Subject: SQUEAKING / GRINDING NOISE FROM REAR BRAKES	Bulletin No: 04-005/15
	Last Issued: 10/14/2015

APPLICABLE MODEL(S)/VINS

2013-2014 CX-5 with VINs lower than JM3 KE*****401869 (produced before Oct. 9, 2013)

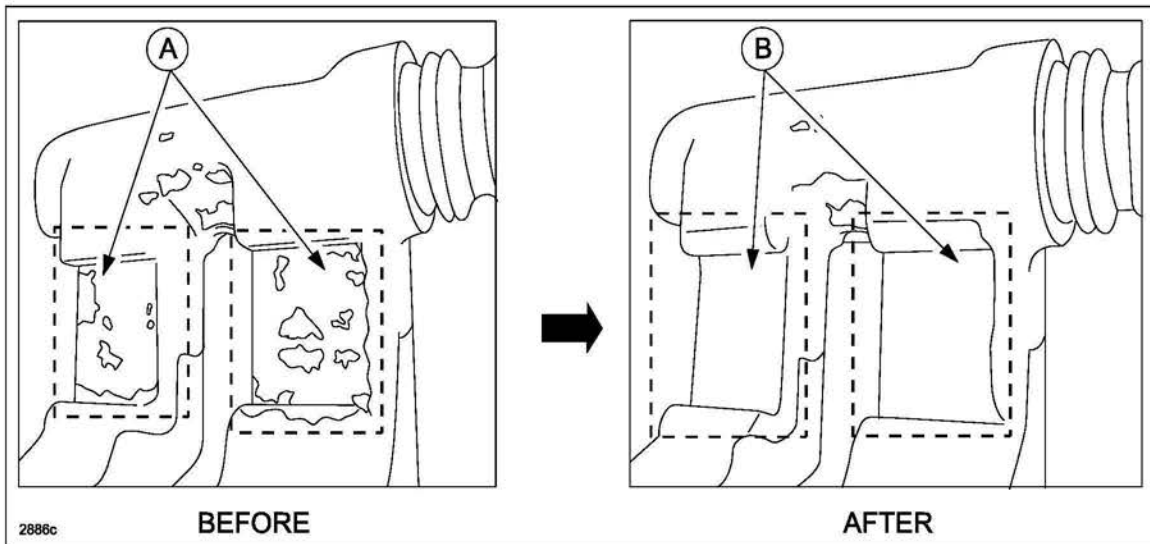
1. Remove the brake pads and retainers (A) from the rear brake caliper support and discard them.

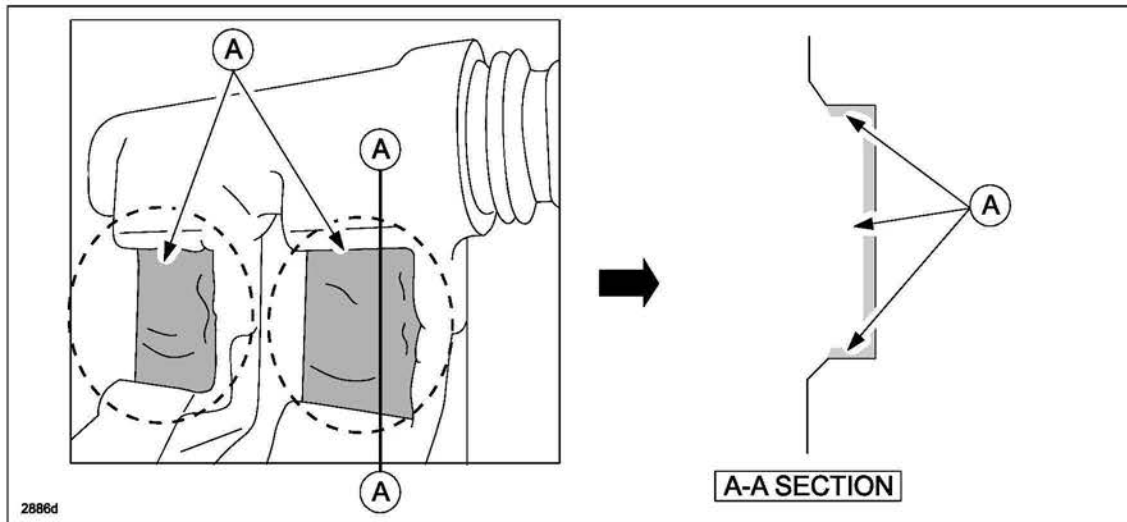
- Using a wire brush, remove all rust from the rear brake caliper support area (A) until the surface turns glossy (B).

- Wipe the area clean, then apply black grease to the area (A) as shown below.

NOTE: Use the black grease included in the rear brake pad sub set / rear brake pad attachment.

PART(S) INFORMATION

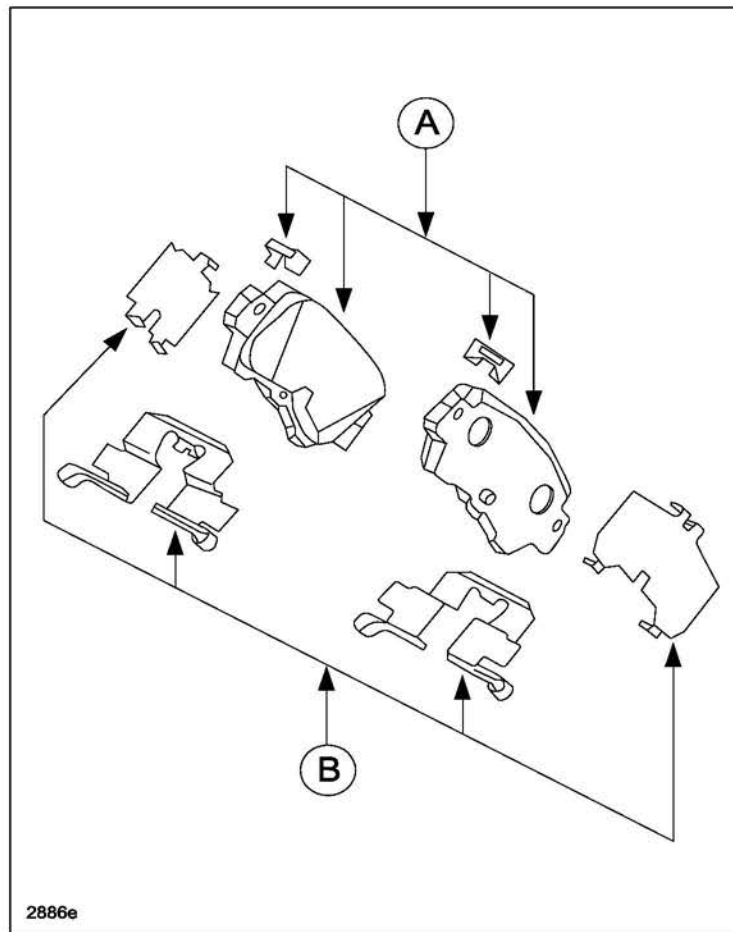
Part Number	Description	Qty.	Notes
K0Y1-26-43ZC	Rear Brake Pad and Attachment Set	1	New service part includes A and B
K011-26-251B	Rear Brake Disc Plate	1 or 2	Replace if necessary
